Magnum BD (Pvt) Ltd; International Classic Composite Ltd (ICCL) (Extension)

Naojur, Kodda, Joydebpur
(23.992545, 90.357336)
6 November 2025

Observation-1: Mismatch in prepared as-built drawings. [Three (3) Storied Steel Building]

Roof bracing layout

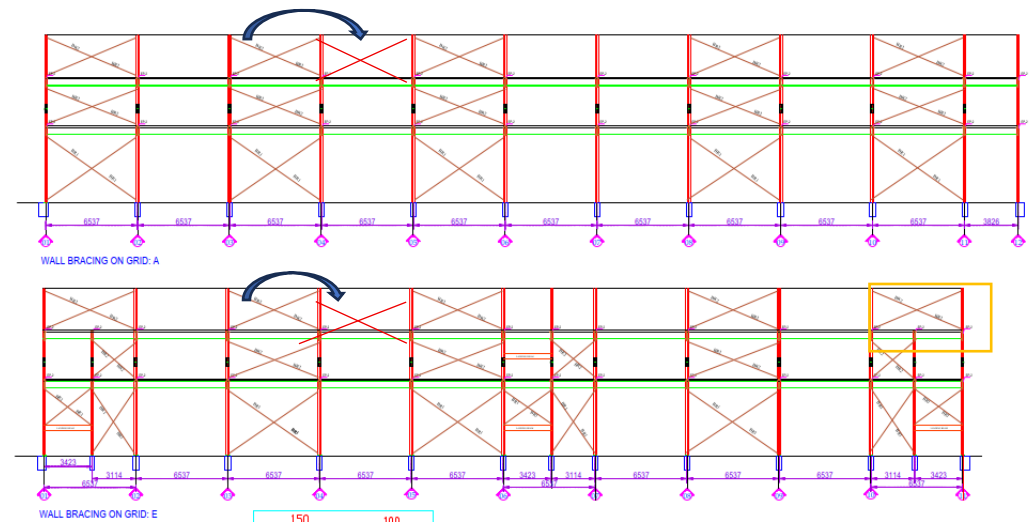
Description: Roof bracings found on site at the marked location but not provided in the as-built drawings. The compression strut was found missing in the E/10-11 grid.

Description: Wall bracings shifted to the adjacent bay at the marked location. Also, wall bracing was not found in the E/10-11 grid. Moreover, mismatch found in connection joint between rafter-column and roof bracing. Building engineer is required to survey the structure and prepare an accurate as-built drawing.

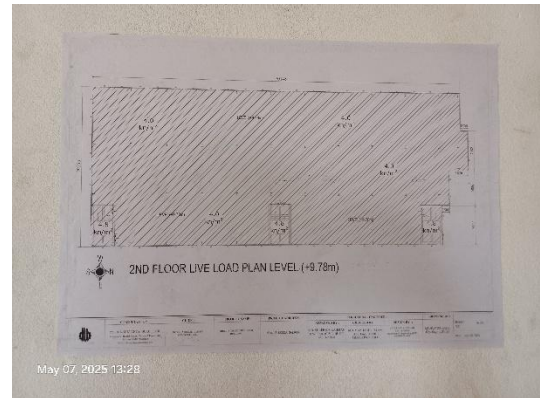
Description: The 2nd floor of the building is allotted for storage. As per BNBC, the minimum floor live load for storage is 6 kN/m² (125 psf). But the 2nd floor of the building is designed for 4 kN/m² live loads.

Building engineer is required to revise the load plan and related design documents based on BNBC requirements.

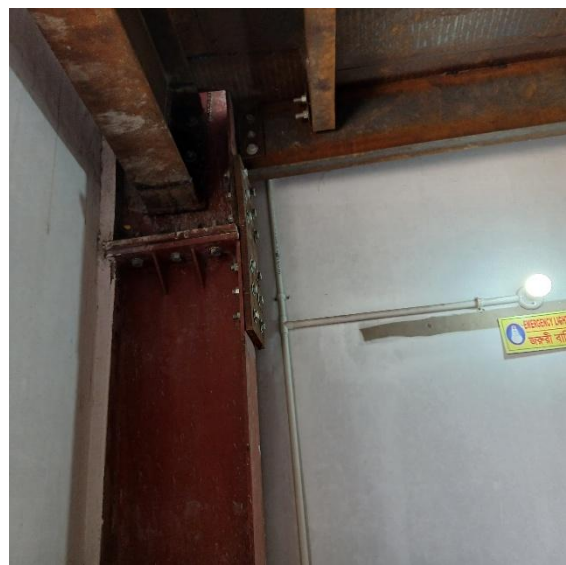
Description: During the inspection, corrosion was observed on several steel members. The factory is required to remove rust and apply anti-corrosive paint on steel members.
